COACH MODEL : T2140, T2145 and C2045 with DD13 Engines
DATE : 11/09/2012
SUBJECT : Auxiliary Air Leak With Detroit Diesel Engine Code 4335/1

Viewed through the Turbo access panel left side of code.

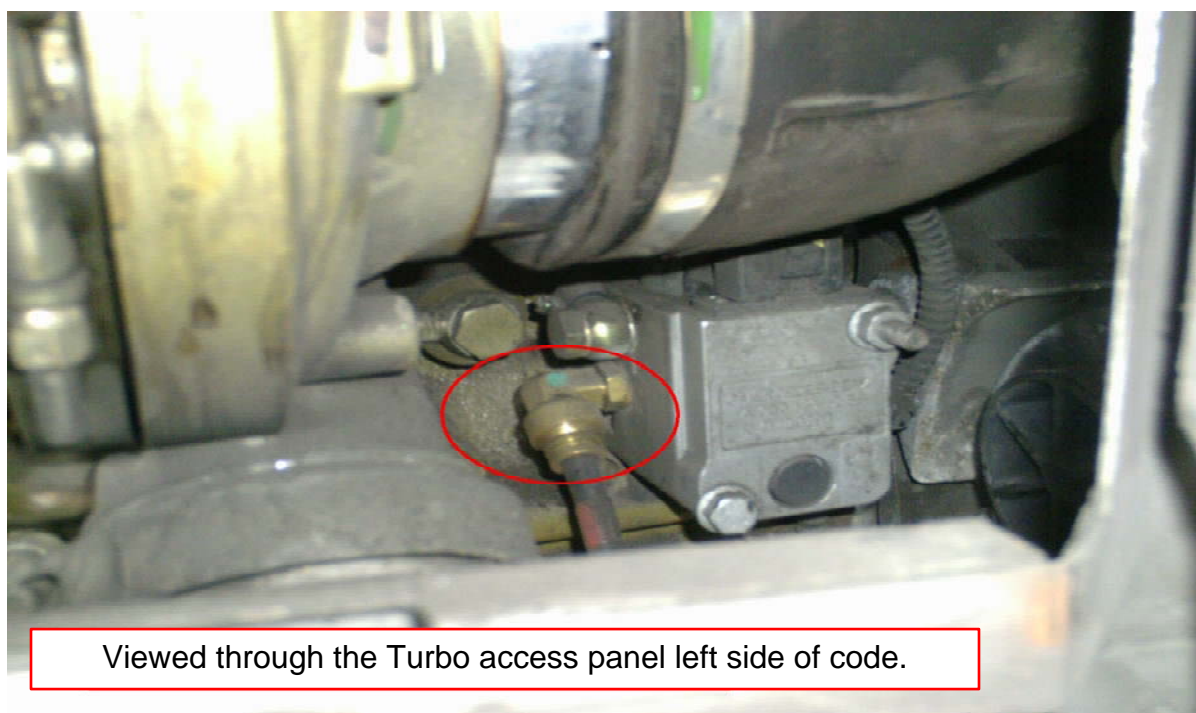
Detroit Diesel has identified a potential air leak at the turbo waste gate air fitting and have updated it with a new part and part number.

If the fitting is leaking, some or all of the following symptoms might be present.

- Engine warning light
- Low auxiliary air pressure
- Code 4335/1 (SPN/FMI) Diesel Exhaust Fluid (DEF) air pressure not detected
- Audible air leak

The new part number that is supplied by Detroit Diesel is: A0019977570
